From: Dennis Ritz <dennisritz@gmail.com>
Sent: Friday, February 07, 2014 1:57 PM
To: Gungle, Ashley; Hingtgen, Robert J
Subject: Soitec Solar Development Program Environmental Impact Report PDS2012-3910-12005
Attachments: SDAA EIS TDS Solar Farm-mvv.docx

Re: Soitec Solar Development Program Environmental Impact Report, Log No:
PDS2012-3910-12005
Tierra del Sol, 3300-12-007

Attachment: SDAA response to specific Solar Farm EIA findings

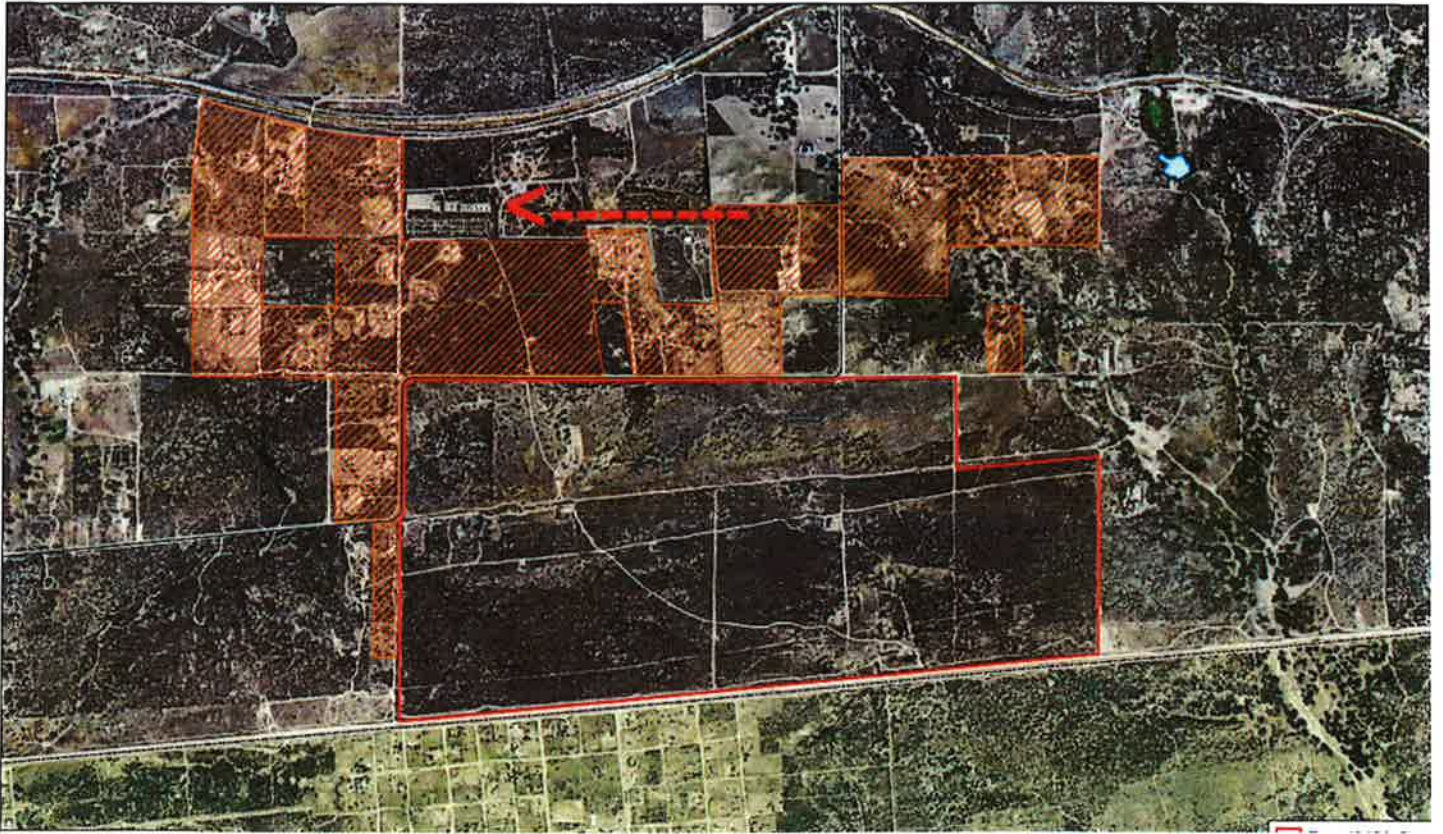
1. Our observatories are located within the map indicating 'sensitive' properties (red crosshatch below). Parcels to our south, east and west are 'sensitive', map figure EIR 2.5-4. Below is the map with an arrow pointing to our property. PEIR page 2.5-26 describes 'sensitive' land uses, but provides no criteria. Our question is: what are the criteria for 'sensitive'? The San Diego Astronomy Association believes our dark night sky observatories at TDS are clearly 'sensitive' to the proposed solar farm night lighting.

2. The next corollary question is whether designation as 'sensitive' impacts our ability to ask/require mitigation measures be required/accepted by the proposer? Do we need to be designated as 'sensitive' to request mitigation; how does the 'sensitive' designation affect our mitigation requests.
